**RE: APPROVAL
RESPONSE TO DISAPPROVAL RAIL CAR LOADING AREA RELEASE SOIL SAMPLING
INVESTIGATION WORK PLAN
WESTERN REFINING SOUTHWEST INC., GALLUP REFINERY
EPA ID # NMD000333211
HWB-WRG-21-001**

**RE: Response to Disapproval
Rail Car Loading Area Release Soil Sampling Investigation Work Plan
Western Refining Southwest LLC, Gallup Refinery
EPA ID #NMD000333211
HWB-WRG-21-001**

Attachment A: Response to Comments

**REVISED RAIL CAR LOADING AREA RELEASE SOIL
SAMPLING INVESTIGATION WORK PLAN**

FIGURE 2

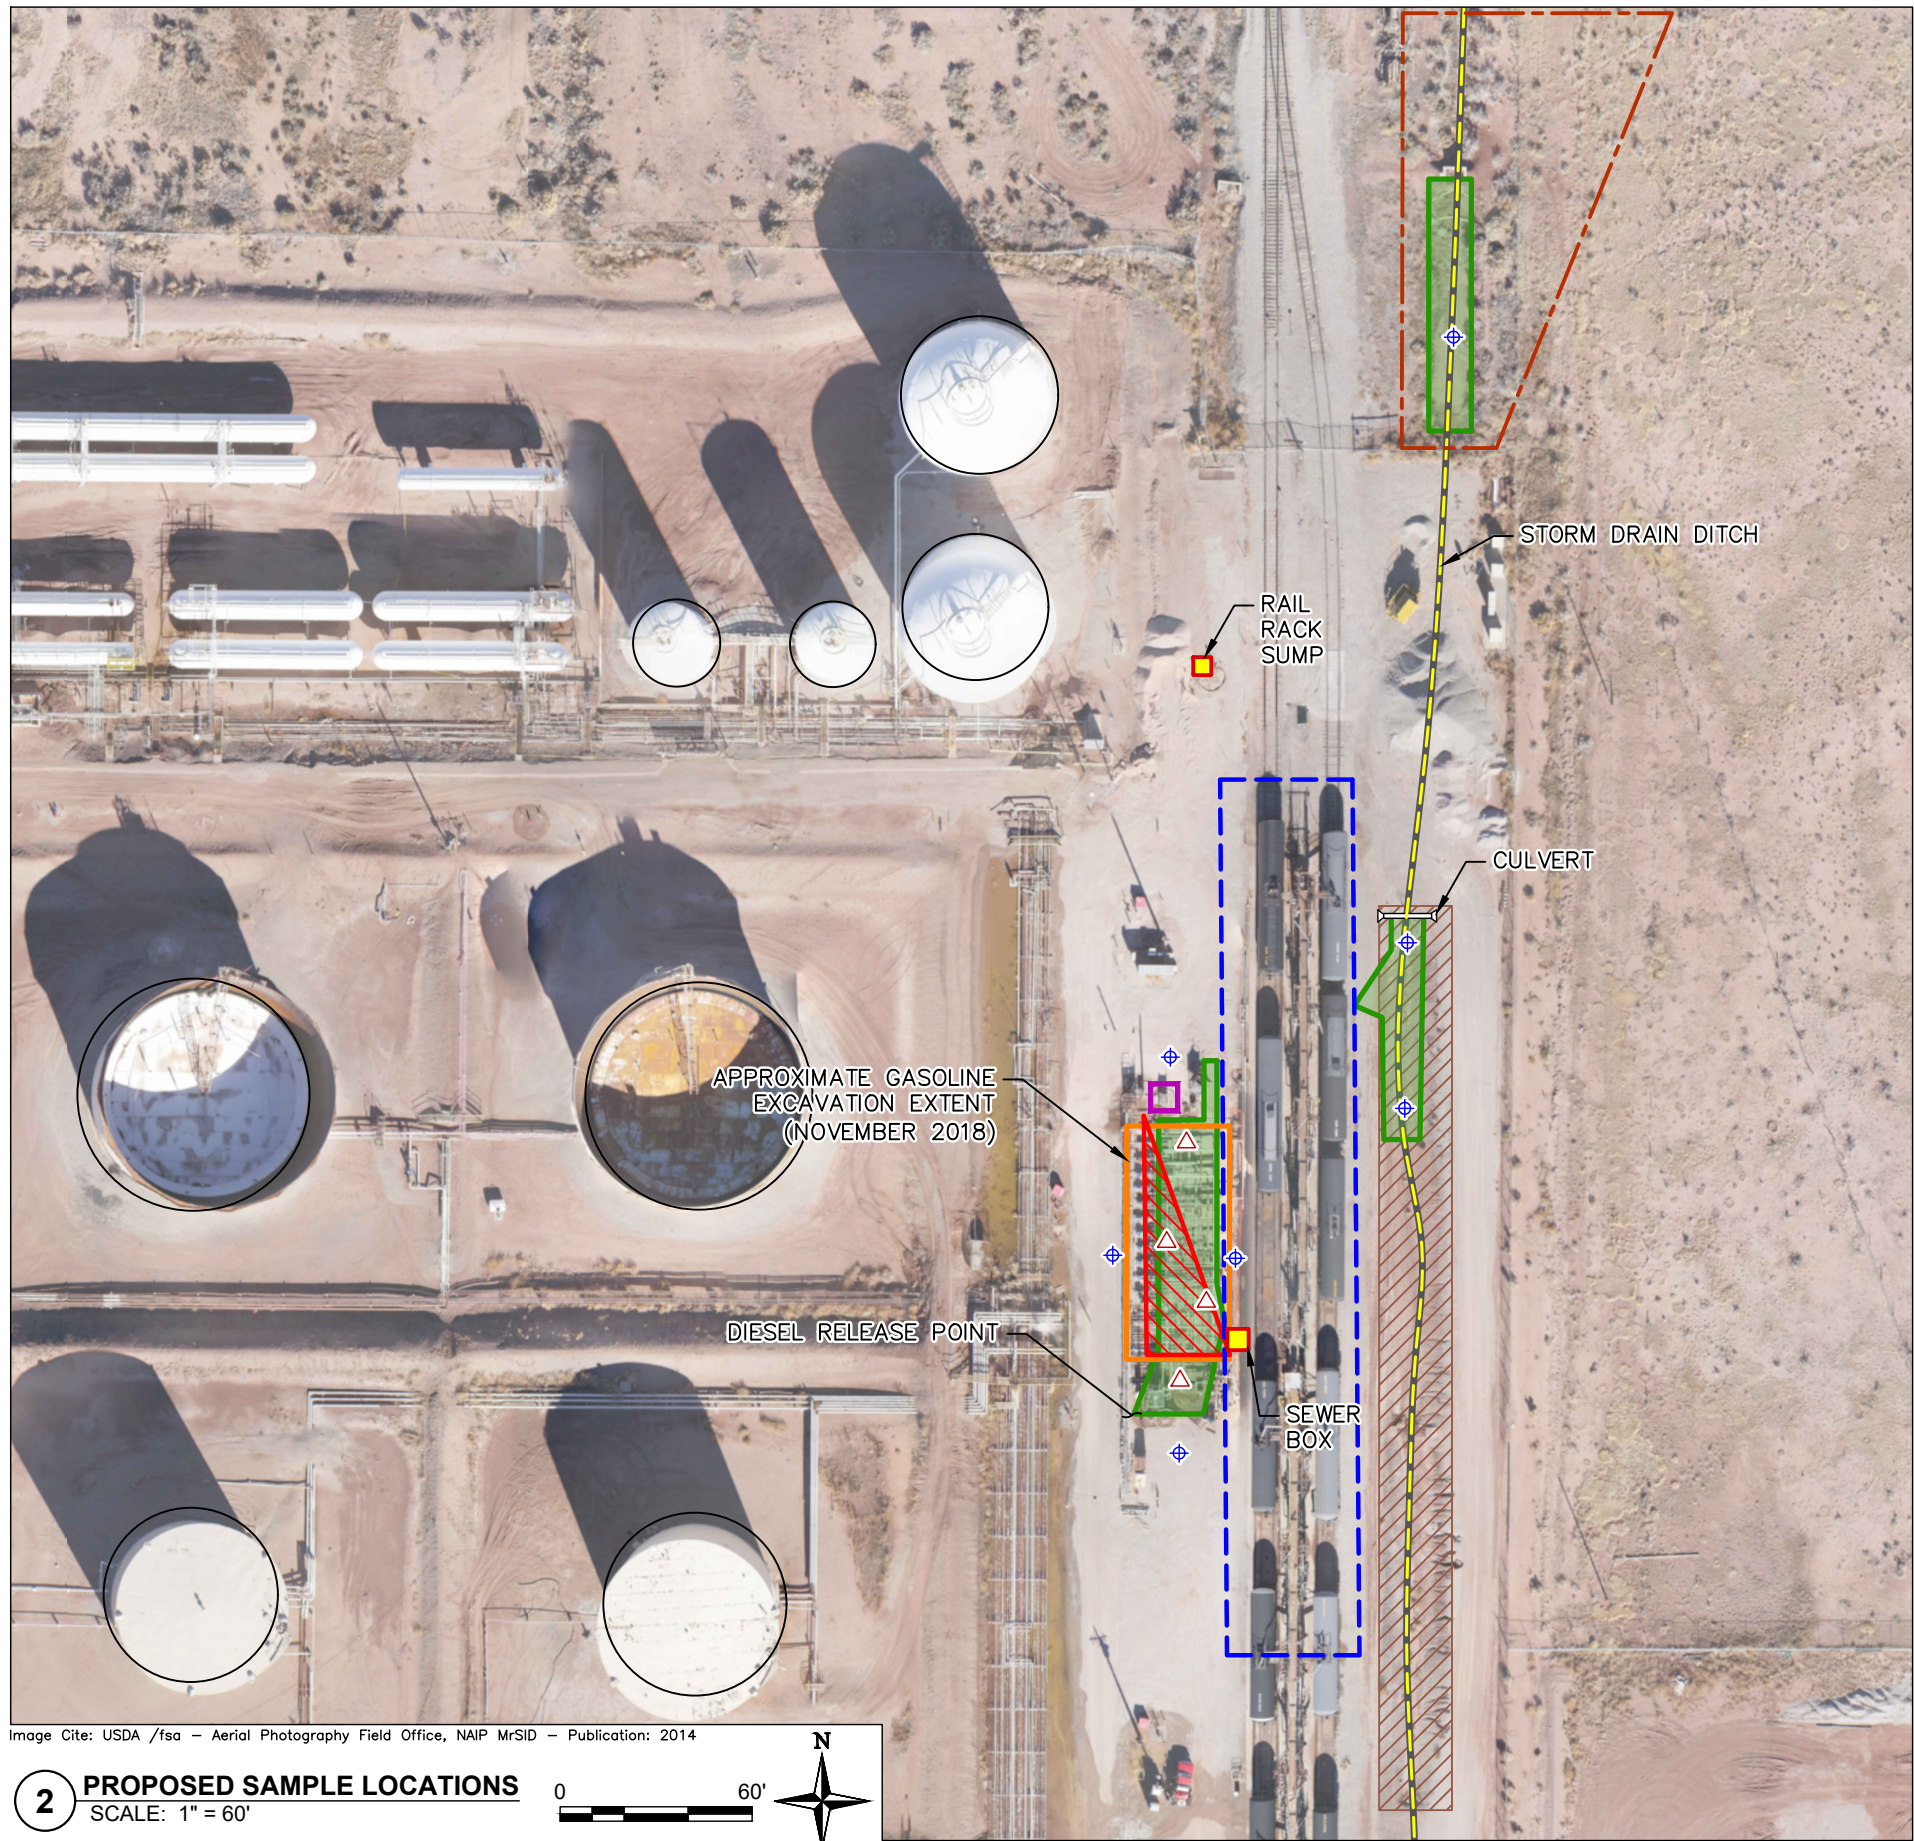
New Mexico Environment Department (NMED) Comments	Marathon Petroleum Company (MPC) Response
Comment 1:	Response 1:
<p>In the Executive Summary, page 3 of 10, the Permittee states, “[d]iesel leaked across the railroad tracks into a culvert carrying product into the stormwater system.” Figure 2, <i>Proposed Sample Locations</i>, does not depict the location of the culvert and the stormwater system. Present the location of the culvert and the stormwater system in a revised figure. In addition, it is necessary to collect soil samples from the stormwater collection ditch where native soils are exposed immediately downstream of the culvert in order to verify whether the diesel release affected the soils in the ditch, if applicable. Revise the Work Plan accordingly.</p>	<p>In response to NMED’s Comment 1, Figure 2 has been revised to present the location of the culvert and the stormwater collection ditch.</p> <p>The Executive Summary, page 3 of 10, has been revised to state, “[i]n addition, the Investigation Work Plan proposes collection of soil samples from the stormwater collection ditch and northern boundary of the diesel release to verify if soils have been affected.” The Work Plan has also been revised in the Scope of Activities Section, page 6 of 10, to state, “[s]oil samples will be collected at the following locations:</p> <ul style="list-style-type: none"> • Four locations within the gasoline release excavated area • Five to eight locations at the stormwater collection ditch and northern boundary of the diesel release. The total number and location of borings will be based on visual observations (e.g., discolored soil, stressed vegetation, low topography). The stormwater collection ditch will be sampled where native soils were exposed, downstream of the culvert . The northern boundary samples will be collected to verify whether the area was affected and if released diesel could have potentially accumulated in topographically low areas. <p>Samples will be collected with a hand trowel and/or a hand auger, at 6-inches bgs and 1-ft bgs. The number of collected soil samples at the ditch and northern boundary will be dependent on visual impacts and indicators.”</p>
